Agenda Item # 5
SUB-003442-2025

Location: 3520 Spanish Alley	Applicable Codes, Policies, and Plans: • Unified Development Code • Subdivision Regulations • Map for Mobile Comprehensive Plan												
Subdivision Name: Sunset Creek Subdivision, Resubdivision of Lots 1 - 3	Proposal: • Subdivision approval to create one (1) legal lot of record from three (3) existing legal lots of record.												
Applicant: Philip & Christa Quinley	Commission Considerations: 1. Subdivision proposal with ten (10) conditions.												
Property Owner: Philip & Christa Quinley													
Current Zoning: R-1, Single-Family Residential Suburban District	Report Contents:												
Future Land Use: Low Density Residential

SUNSET CREEK SUBDIVISION, RESUBDIVISION OF LOTS 1-3

APPLICATION NUMBER 5 DATE September 18, 2025

DETAIL SITE PLAN

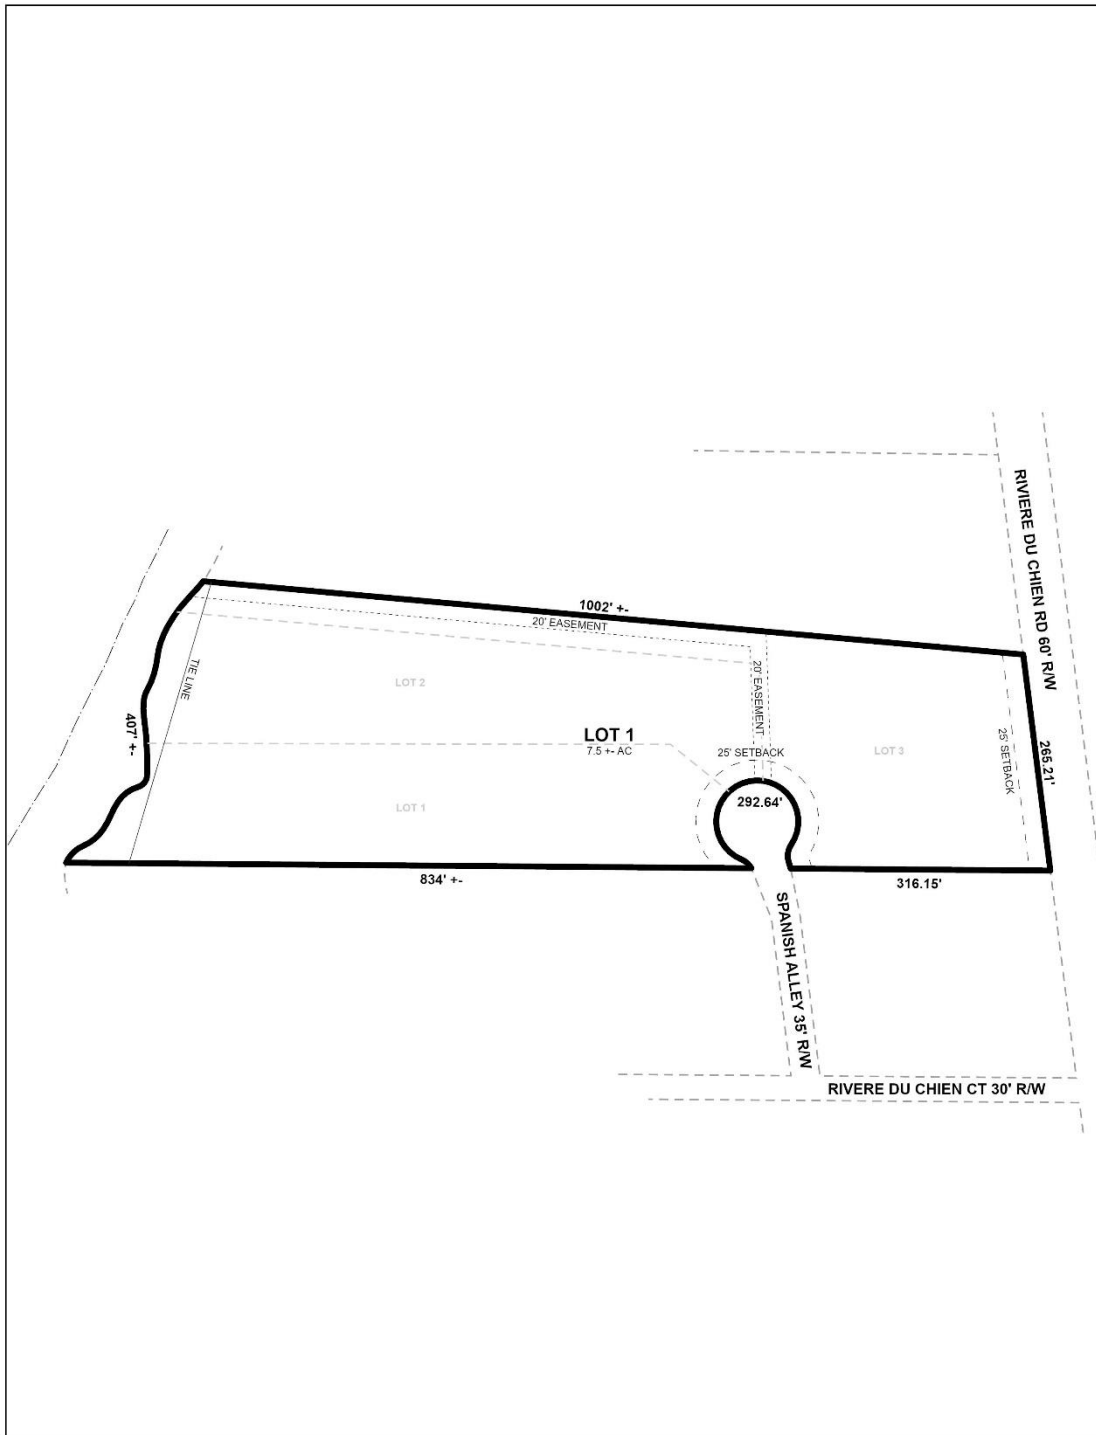
- B. National Wetlands Inventory (NWI) mapping, as shown on City of Mobile GIS information, indicates that there is potential for wetlands within the property or properties shown on this plat. Show and label the delineated wetlands or provide a note stating that the wetlands shown on this plat are scaled from the NWI data and have not been delineated.

- C. Provide a note that a 25' riparian buffer may be required, during development, along the edge of anything considered by ADEM to be a water of the state.

- D. Show and label the MFFE (Minimum Finished Floor Elevation) on each lot that contains an A, AE, or X (shaded) flood zone designation. BFE = 11.
- E. Revise NOTE 13 – change “...LOT 1 - _____ SF.” to “...LOT 1 - 7,400 SF.”

The site has frontage on the North terminus of Spanish Alley and Riviere du Chien Road. The North terminus of Spanish Alley is a cul-de-sac with a current 50-foot diameter. As current Fire Department standards call for a 60-foot radius to allow access for larger fire fighting equipment, dedication should be required to provide a 60-foot radius. Riviere du Chien Road is a minor street without curb and gutter and with a compliant 60-foot right-of-way. Therefore, no dedication would be required along Riviere du Chien Road. Both streets should be labeled with their right-of-way widths, after any required dedication, on the Final Plat, if approved.

As on the preliminary plat, the 25-foot minimum building setback line along both street frontages should be retained on the Final Plat, if approved, adjusted for any required dedication.

The proposed lot would exceed the minimum area requirements of the UDC for lots in an R-1, Single-Family Residential Suburban District. As on the preliminary plat, the lot size label in both square feet and acres should be retained on the Final Plat, if approved, adjusted for any required dedication, or a table should be furnished on the Final Plat providing the same information.

The site has a 20-foot drainage easement within it. Therefore, a note should be required on the Final Plat, if approved, stating that no structure shall be constructed or placed within any easement without the permission of the easement holder.

The proposed lot would exceed the maximum depth-to-width ratio allowance of Section 6-C.3. of the Subdivision Regulations. However, as this lot would retain the existing ratio of the parent parcel, a waiver of Section 6-C.3. would seem in order.

1. Dedication to provide a 60-foot radius for the cul-de-sac at the North terminus of Spanish Alley;
2. Retention of the right-of-way width label for Riviere du Chien Road on the Final Plat;

3. Retention of the right-of-way radius for the Spanish Alley cul-de-sac on the Final Plat, adjusted for any required dedication;
4. Illustration of the 25-foot minimum building setback line along both street frontages on the Final Plat, as measured from any required right-of-way dedication;

5. Retention of the lot size label in both square feet and acres on the Final Plat, adjusted for any required dedication, or the furnishing of a table on the Final Plat providing the same information;

6. Placement of a note on the Final Plat stating that no structure may be constructed or placed within any easement without the permission of the easement holder;
